**REZONING, PUD &
SUBDIVISION STAFF REPORT****Date: May 19, 2005****APPLICANT NAME**Cypress Equities Southeast, L.L.C.
(John Farrow, Agent)**DEVELOPMENT NAME**

Cypress Equities Subdivision

LOCATION6575 Airport Boulevard
(South side of Airport Boulevard, 2/10 mile± West
of Hillcrest Road).**CITY COUNCIL
DISTRICT**

SITE PLAN

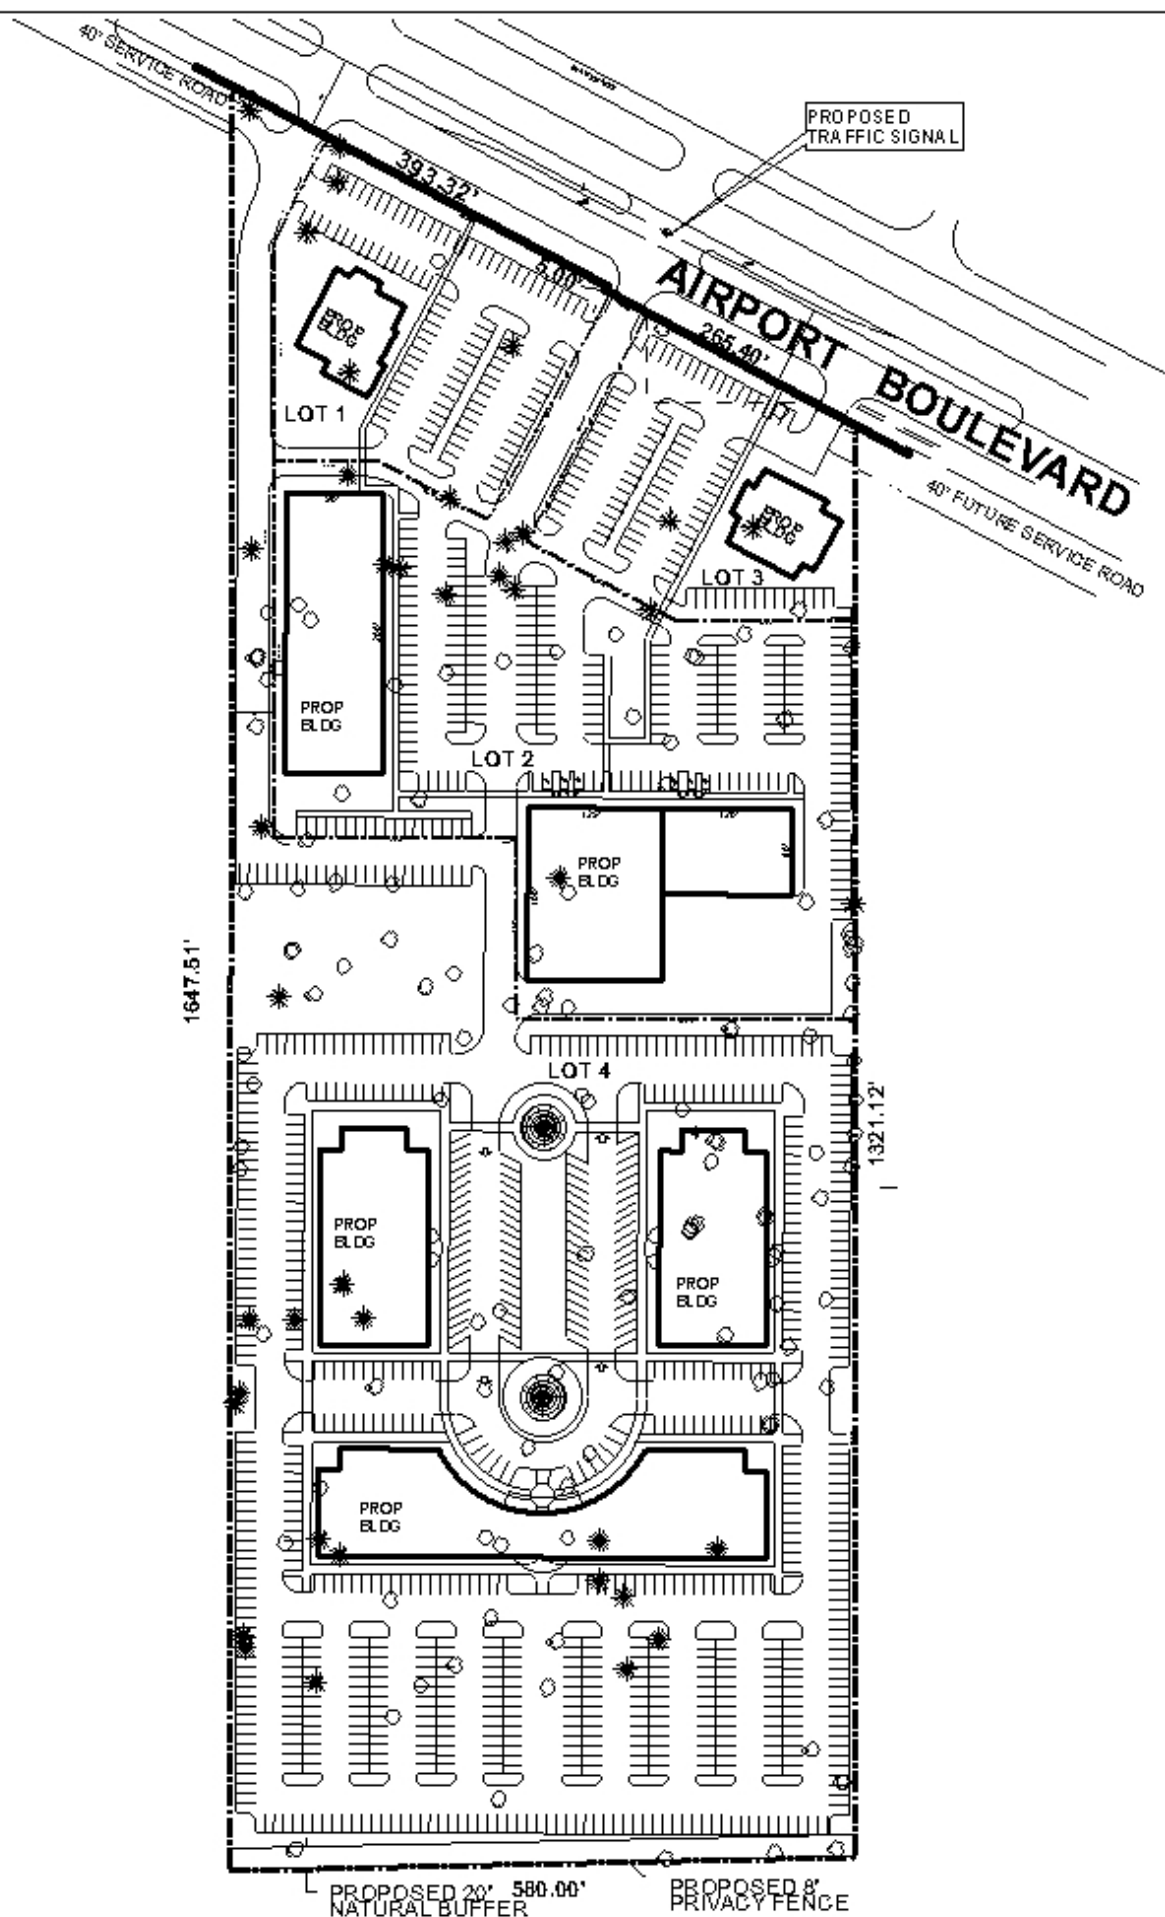
The site is located on Airport Boulevard, a major street on the city's Major Street Plan; therefore, access to Airport Boulevard is a concern. The plan as submitted indicates three access points to Airport Boulevard, one of which will require a new median cut and signalization. A fourth access point to the site is from the service road adjacent to the West. Based upon comments from the Traffic Engineering Department, additional modifications to the existing median cut (West side of the site) will be necessary as a result of this development). All of these improvements should be completed prior to the issuance of any Certificates of Occupancy within the proposed development.

The plan appears to meet the general locational requirements for PUD approval. However, as submitted, the plan does not reflect the provision of buffering where the proposed development abuts residential properties (along the South property line and a portion of the east property line). Therefore, if approved, the provision of an 8' privacy fence should be required.

With regard to the proposed subdivision, two of the four lots are "flag" lots. The Subdivision Regulations state that the depth of a lot should be no more than three and one-half times the width of the lot. While the "flag" lots technically exceed that recommendation, PUD approval will allow the development to function as a single building site. Therefore, a waiver of Section V.D.3 would be appropriate. With that waiver, the plat meets the minimum requirements of the Subdivision Regulations.

Planned Unit Development: 1) intersection improvements (including signalization) and median modifications, as recommended by Traffic Engineering, to be completed prior to the issuance of any Certificates of Occupancy; 2) completion of the rezoning and subdivision processes; 3) provision of an 8' privacy fence along the South and East property lines, where the site abuts residential properties; and 4) full compliance with all municipal codes and ordinances.

Subdivision: With a waiver of Section V.D.3, the plat will meet the minimum requirements of the Subdivision Regulations and is recommended for Tentative Approval, subject to the following conditions: 1) intersection improvements (including signalization) and median modifications, as recommended by Traffic Engineering, to be completed prior to the issuance of any Certificates of Occupancy; and 2) development limited to the accompanying PUD.
